T-11

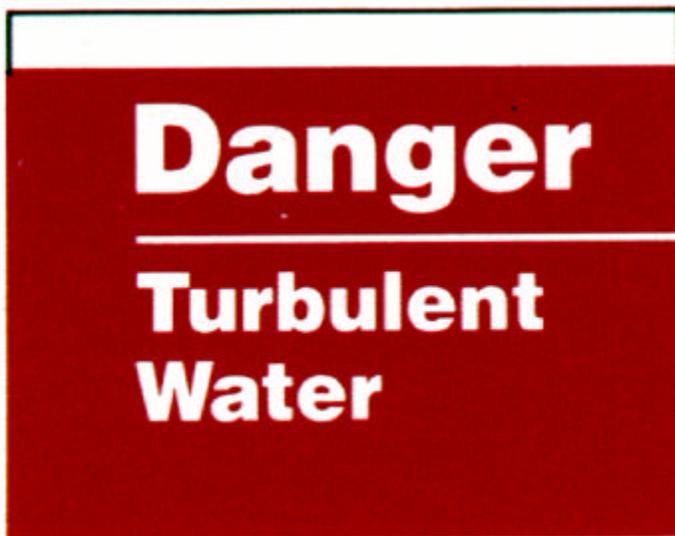
Good example of  
modifying signage  
needs based on new  
recreational activities.  
Changing use may  
increase the need for  
additional signage.

Sign should be mounted  
to same size backing.  
Recommend  
re-mounting.
